ASB-1050

Service Bulletin

Subject: TS-950SDX Sub Band Residual Noise

Date: March 28, 1994

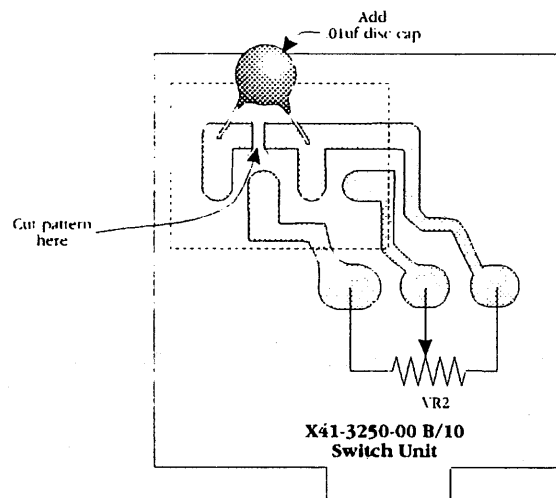
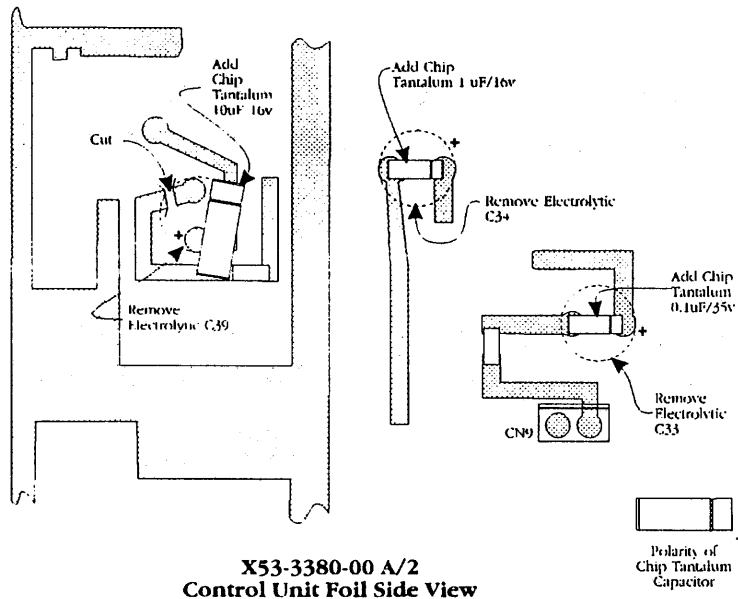
Replacing the Control Unit electrolytic capacitors (C33, C34, and C39) with Tantalum capacitors, and adding the bypass capacitor to the Switch unit reduces or eliminates this symptom.

Qty	Description	Kenwood Part No.	Circuit Description
1	0.1 uF 35v Tantalum cap	C92-0001-05	C33
1	1.0 uF 16v Tantalum cap	C92-0004-05	C34
1	10 uF 16v Tantalum cap	C92-0505-05	C39
1	.01 uF disc capacitor	CK45B1H103Z	NA
